DOCKETS 50-266 AND 50-301
SUBMITTAL OF QUALITY ASSURANCE PROGRAM DESCRIPTION CHANGES
POINT BEACH NUCLEAR PLANT, UNITS 1 AND 2

FSAR 1.8 Changes - 1993 Update

FIGURE 1-B-1

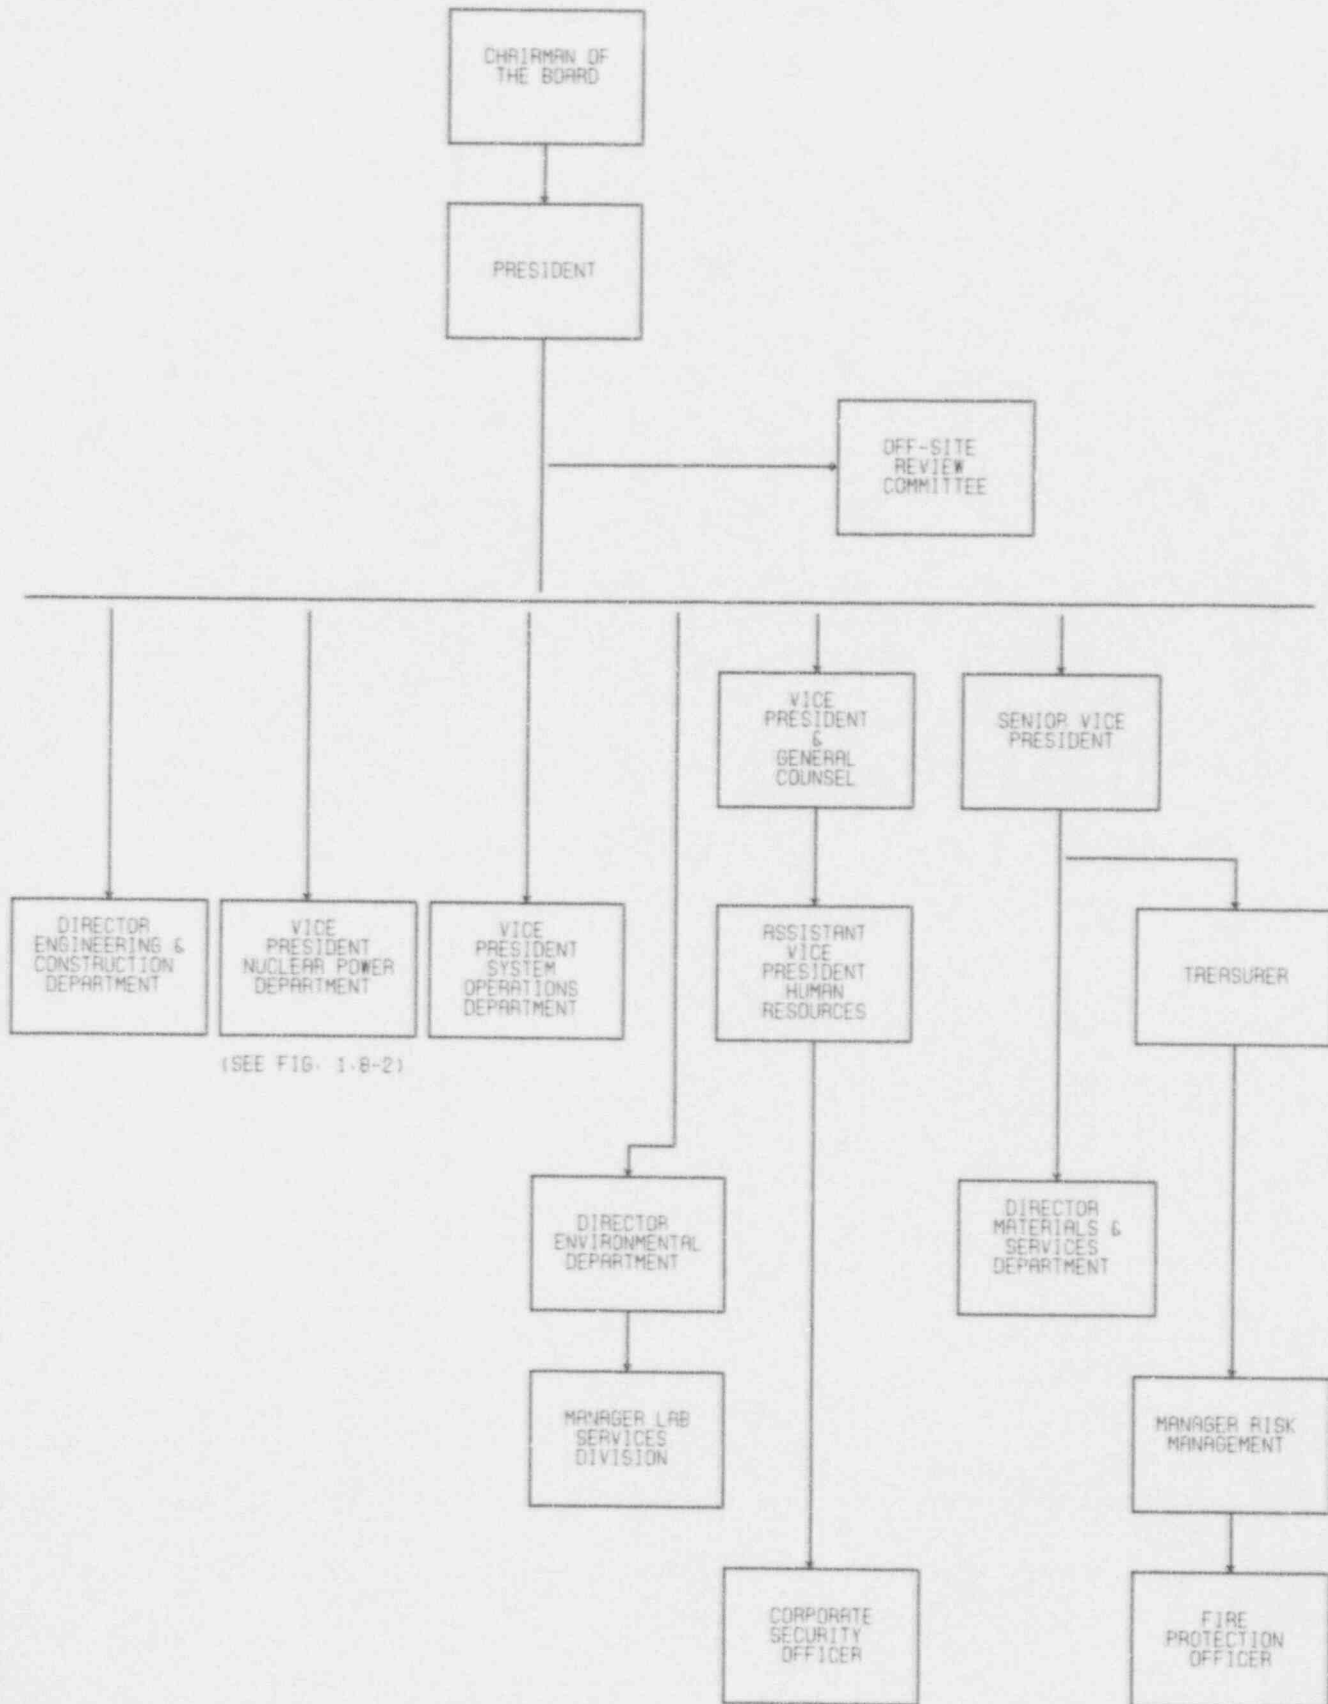
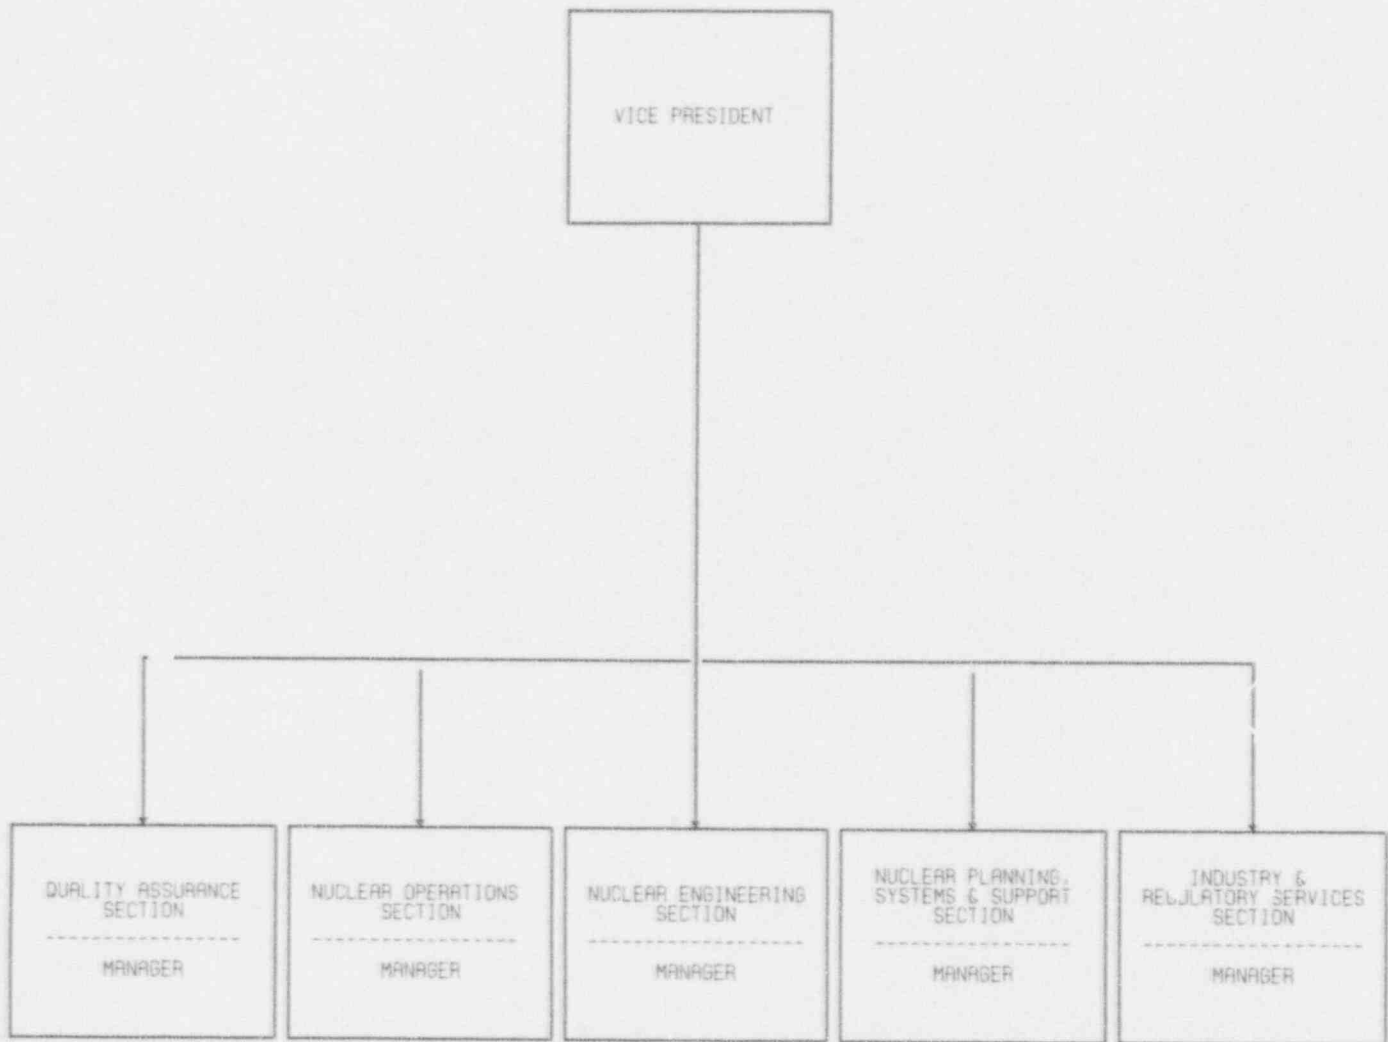
6. Page 1.8-22 Last paragraph - Deleted 1st sentence "In a footnote. . ."
7. Figure 1.8-1 Changed title of Vice President Human Resources to "Assistant" VP HR.

Figure 1.8-3

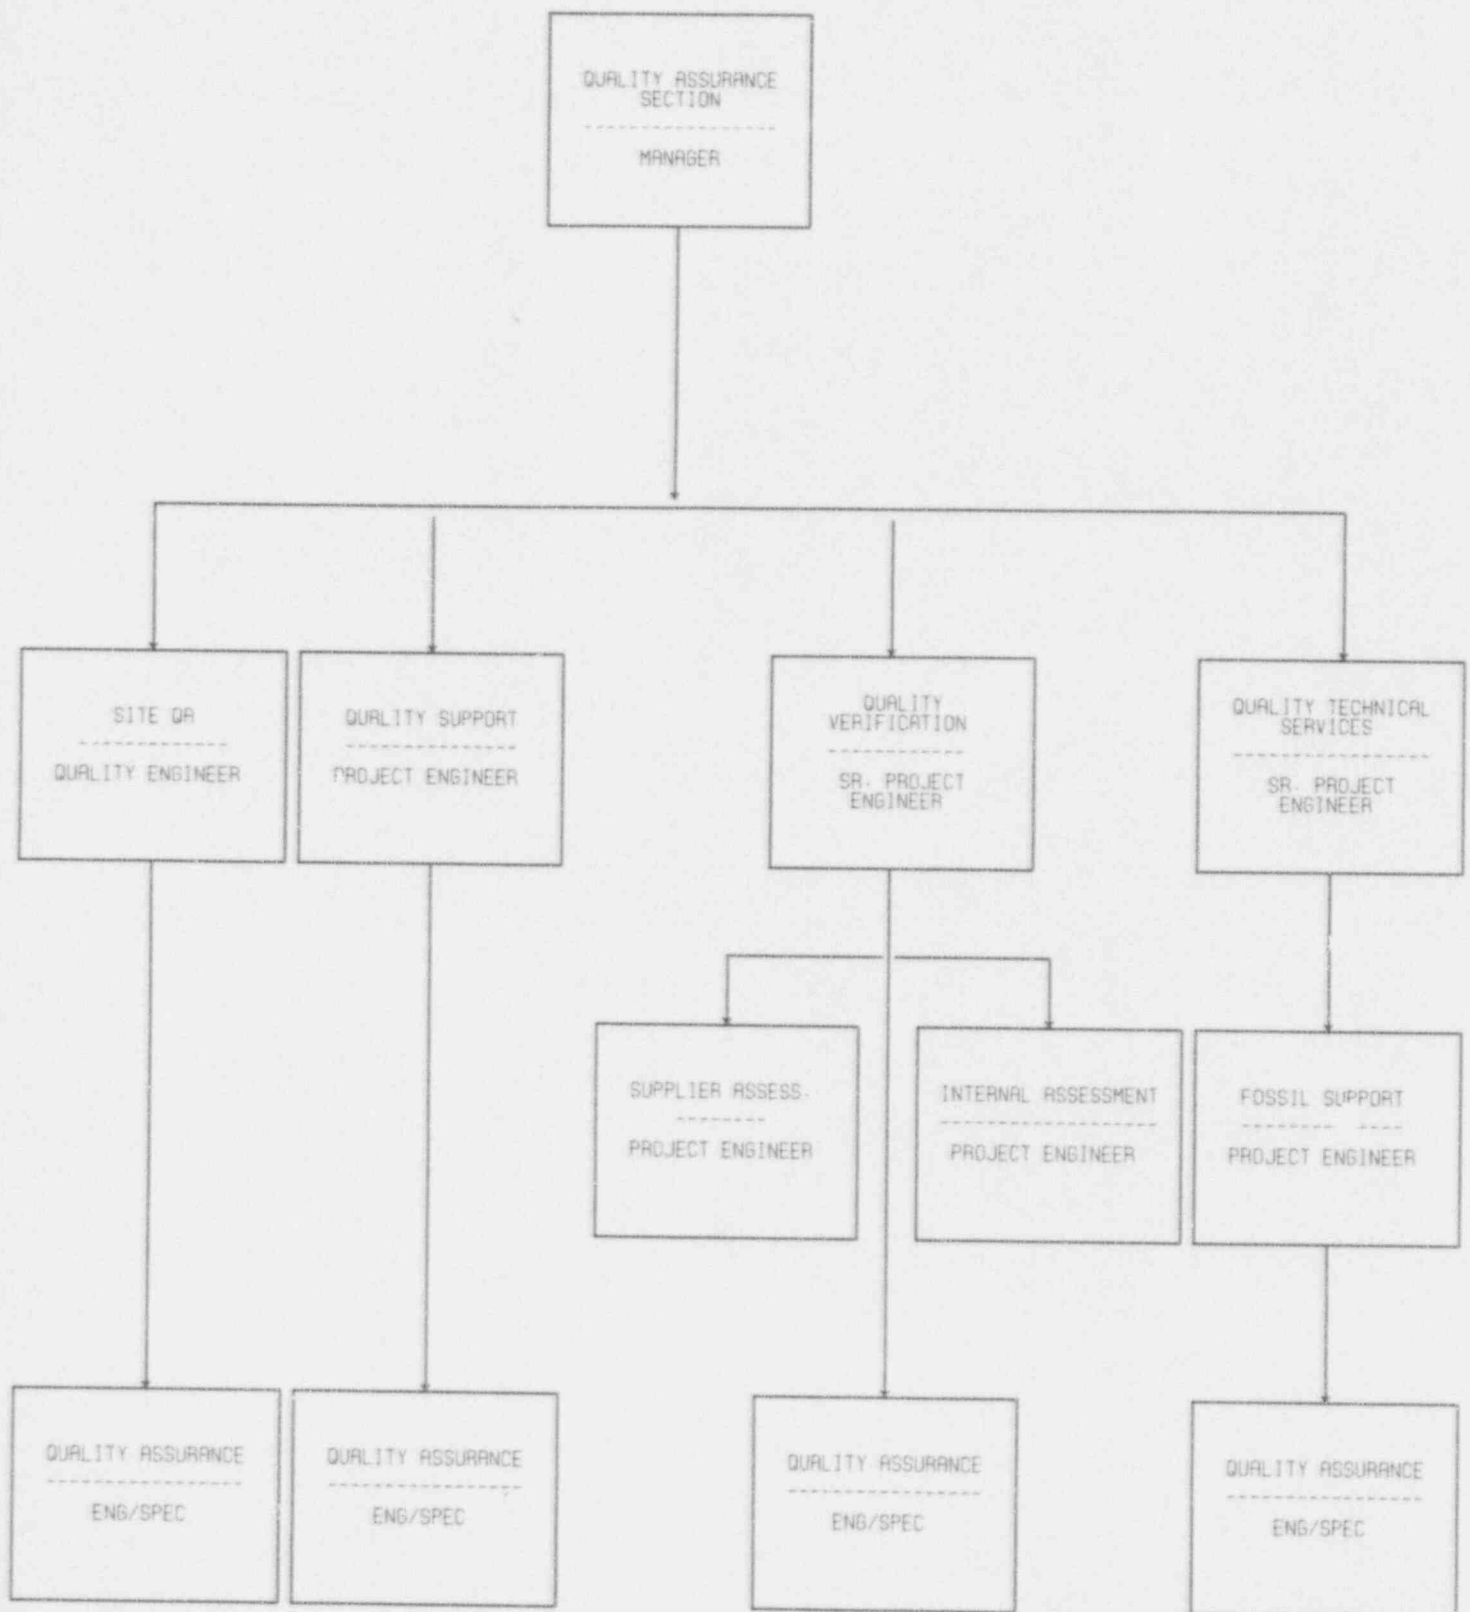
8. Figure 1.8-2 Revisions to reflect changes in NPD Section titles. No major structural changes.
9. Figure 1.8-3 Revisions to reflect recent changes in QAS organization, denoting minor structural changes.
